LOT 2 DP 301351, 346 MORVEN FERRY ROAD ENGINEERING DRAWINGS

EARTHWORKS, ROADING AND SERVICES
JOB No. 13905

Subject: RE: RM230365 - Robertson - Questions arising while drafting s 95 report

RFI RESPONSE - RM230365

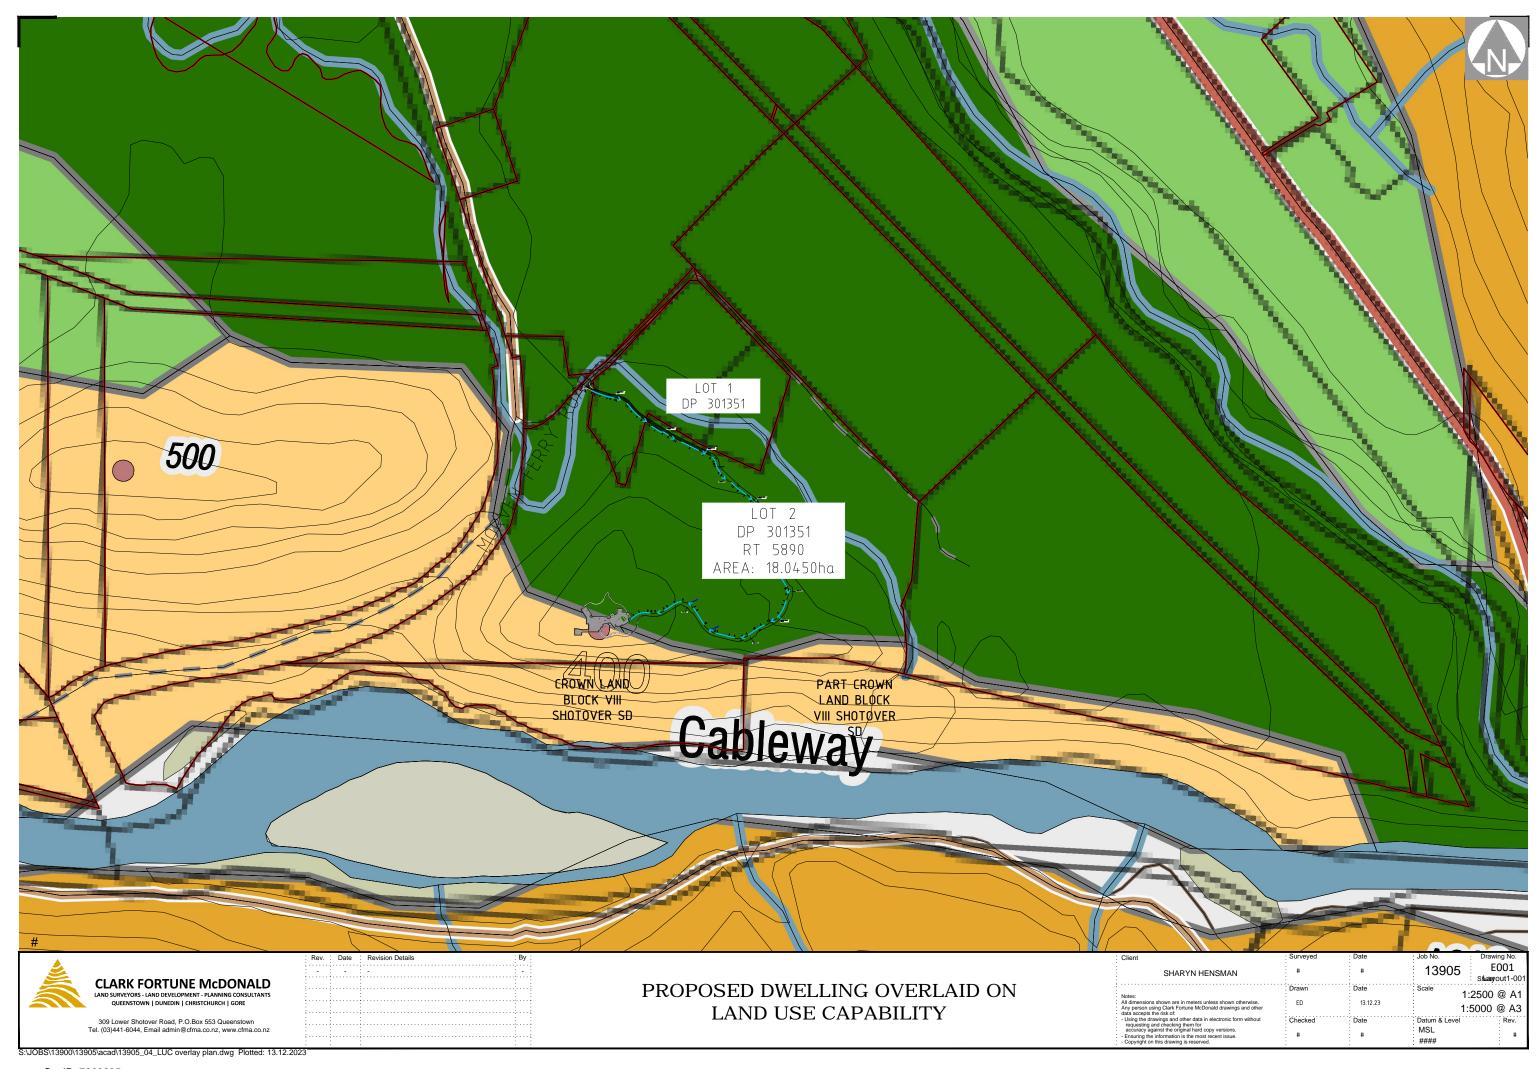
- 3. You state that the dwelling is contained wholly within land classified as LUC 6 but it appears it may be very close to, if not within LUC 2. Can you please overlay the site plan over the LUC plan and confirm that it is wholly within LUC6 as stated in the AEE. I have overlaid the plan showing the dwelling on the LUC map and it is pretty crude given it is a pdf overlay and the width of the line between the two LUC's is nearly 15m, it does however show a portion of the dwelling in the LUC2 area. Plan attached for your reference.

Figure 1: Visibility Map Overview

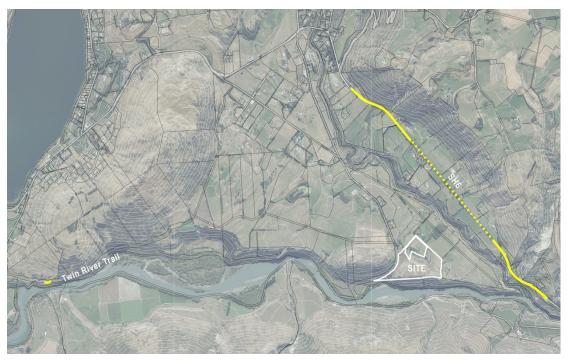
- 5. Please provide a visibility map overview map showing the areas that the proposal will be visible from in SH6 and the Twin Trail (as outlined in point 5.2 in the LVA).
- 14. Refer to Figure 1 below. The western 'tunnel' portion of the proposed dwelling may be potentially visible for a 50m portion of the Twin Rivers Trails, approximately 4.13km away from the site. From SH6, part of the proposed earthworks and driveway will be visible from SH6 (solid yellow line) to the north of the site for approximately 1km and east of the site for approximately 1km. The proposal may be visible intermittently (dotted yellow line) through off-site vegetation for approximately 1.6km of SH6. No part of the proposed building will be visible from SH6.

3D Model Views 28 August 2023

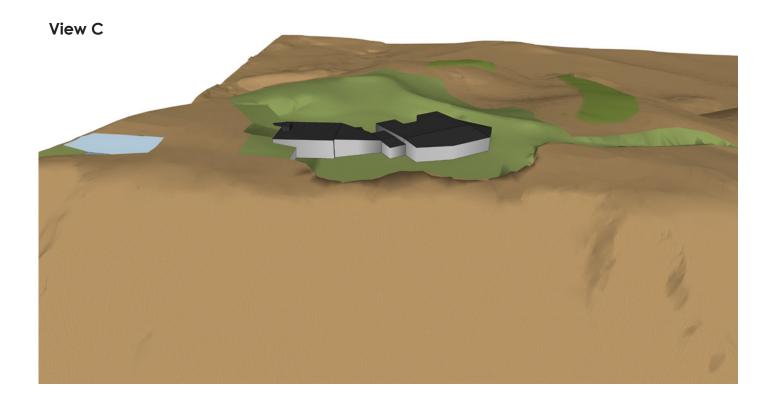
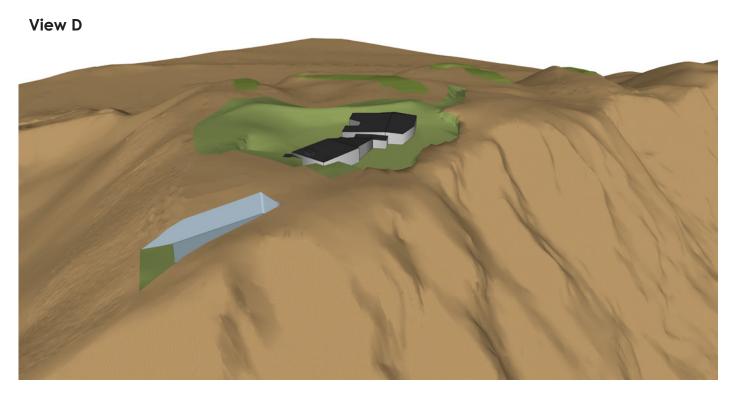
- ii) Please provide landscape elevations of the proposed mounding (additional to the engineered details).
- 7. We have reviewed this request and do not consider 'elevations' are the most appropriate graphic representation tool to communicate the intended earthworks. Instead we provide stills of our 3D model (Attachment AA), which are attached to this RFI. Those 3D stills represent the existing ground and proposed earth-worked areas.
